# Chapter 8

## Product History

### 8.2 Backdating History

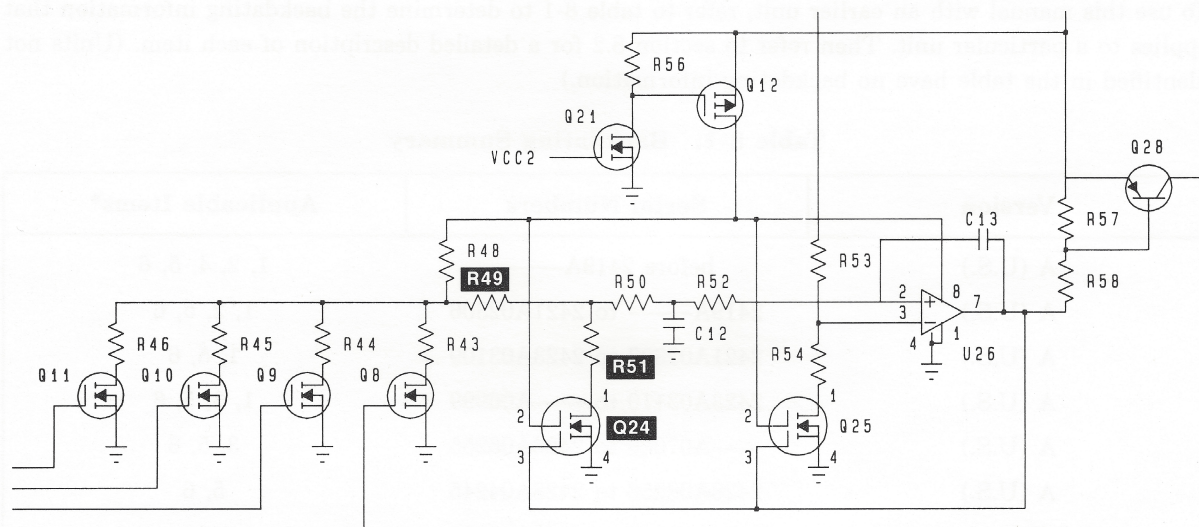
2. **Version A, serial numbers through 2421A02306.** Transistor A2Q24 and resistors A2R49 and A2R51 are not as specified in chapter 6. If one of these components fails, replace it according to the following list. (Service Note 110-02.)

The following schematic diagram shows how these components are connected in the LCD supply circuit on the I/O PCA (see figure 9-7).

Reference Designation	HP Part Number	Description
Q24	1855-0557	TRANSISTOR, dual-gate MOSFET, 20V
R49	0757-0463	RESISTOR, 82.5 k $\Omega$ , 1%, $\frac{1}{8}$ W
R51	0757-0278	RESISTOR, 1.78 k $\Omega$ , 1%, $\frac{1}{8}$ W
